**LAND AT TODDINGTON LANE,
TODDINGTON, WEST SUSSEX**

**PROPOSED HIGHWAY WORKS &
DEVELOPMENT ACCESS**

**STAGE 1
ROAD SAFETY AUDIT REPORT**

RKS Associates Ref: VRP899-01

Appendix A

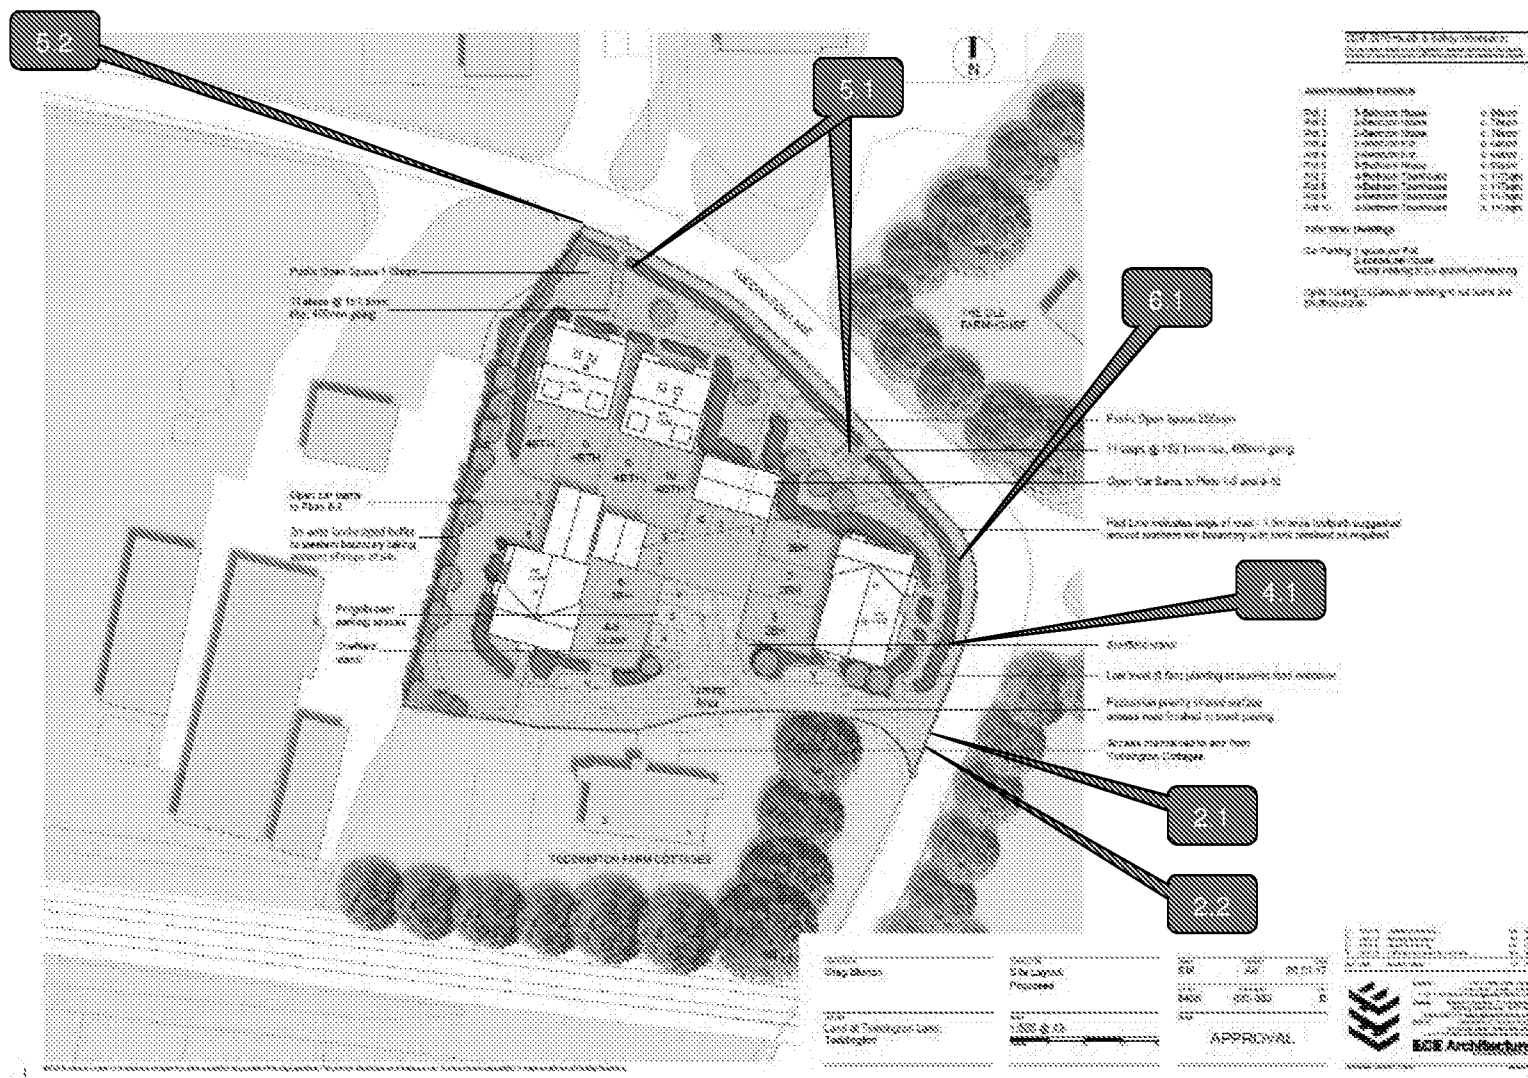
- 1.7** The location of the problems identified in this Safety Audit is shown in **Appendix A** where the reference numbers relate to the problems identified in this report.

Vehicle swept path plots associated with the development access have not been provided. It is therefore not clear whether or not vehicles particularly servicing vehicles will be able to negotiate the proposed access safely. Inadequate geometry could result in vehicles overrunning the footway or opposing carriageway thereby increasing the risk of collisions with other road users at the site access.

No details relating to the visibility splay to the left from the proposed development access have been provided. The scheme drawings indicate that low-level planting (0.6m in height) is to be provided, however the combination of proposed landscaping along the site frontage and the right-hand bend on its southbound approach to the proposed access may restrict visibility for traffic entering and exiting the development. Poor visibility may increase the risk of vehicle collisions.

The proposed scheme drawing indicates that steps are to be provided from the development to the proposed footway along the southern side of Toddington Lane. There is concern that mobility impaired pedestrians and pram users may find it difficult to negotiate the steps. The provision of steps may cause a hazard for these users particularly during adverse weather conditions.

Observations during the site inspection noted that larger residential developments are being constructed to the west of the proposed development. The scheme drawings indicate that a footway along the southern side of Toddington Lane is to be provided, however no further details on how this footway will link up with the wider footway network for the local area. The absence of continuity of footway link may increase the risk of pedestrians walking along the carriageway where the risk of collision with passing traffic will be greater.

The proposed highway works will require the relocation of existing road signs associated with the level crossing. Whilst no details have been provided at this stage, there is concern that poor positioning of these signs may restrict visibility for vehicles exiting the development or cause an obstruction for pedestrians using the proposed footway.

2.2	Provide swept path plots to ensure that vehicles including servicing vehicles will be able to manoeuvre to and from the development access safely.	A swept path drawing of a servicing vehicle manoeuvring accessing and egressing the site is attached in the designer's response.

4.1	Visibility splays to and from the proposed access should be undertaken to ensure that visibility is not compromised by proposed landscaping.	A visibility splay drawing of the proposed access is attached in the designer's response.

5.1	A ramped access arrangement should be provided to link the footway between the development and proposed footway along Toddington Lane.	A level access point will be provided on Toddington Lane, to the east of the site. This access will facilitate access for mobility impaired pedestrians and pram users. It will lead to an on-site footway that will not include steps which will facilitate access to the residential properties.

5.2	Review the pedestrian network, it would be appropriate to link the proposed footway to the wider footway network to accord with the pedestrian desire lines.	A new footway will be provided along the entire frontage of the site. As the adjacent sites are developed, these will the opportunity to link into this footway.

6.1	Ensure that all relocated signs do not obstruct the visibility to and from the proposed development access or cause an obstruction for pedestrian users.	This will be implemented at detailed design stage.
